TECHNICAL BULLETIN
3030 - STD
VS
3030X - INTRAAX

JAN 2017

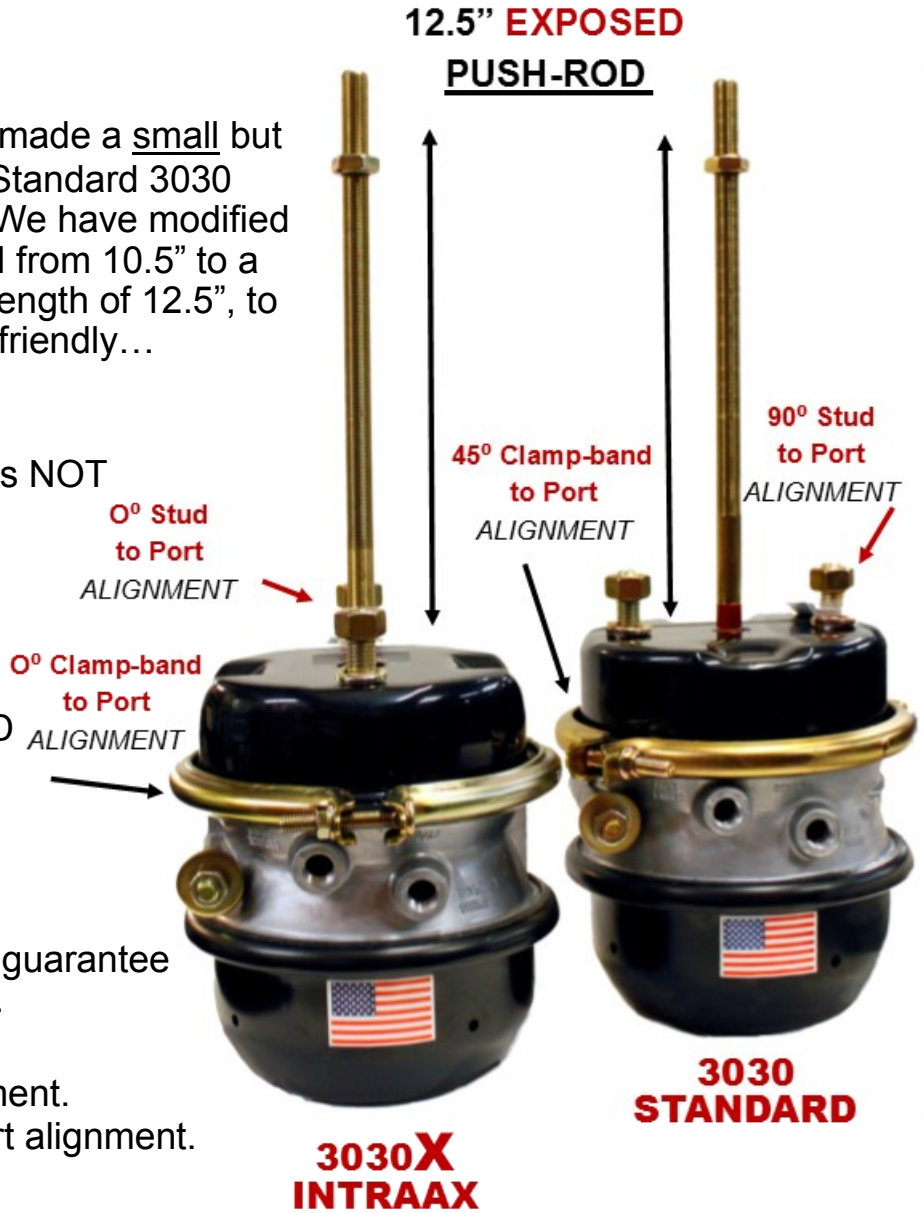
RANGER BRAKE has made a small but important change to our Standard 3030 Tandem / Spring-brake. We have modified the PUSH-ROD LENGTH from 10.5" to a ore versatile **EXPOSED** length of 12.5", to make it mare application friendly...

This simple modification is NOT intended to replace our 3030X-INTRAAX because you will incur increased labor costs in doing so. It just gives you the flexibility to FIELD convert, if in a bind.

- 1). 0° Stud to Port alignment.
- 2). 0° Clamp-band to Port alignment.
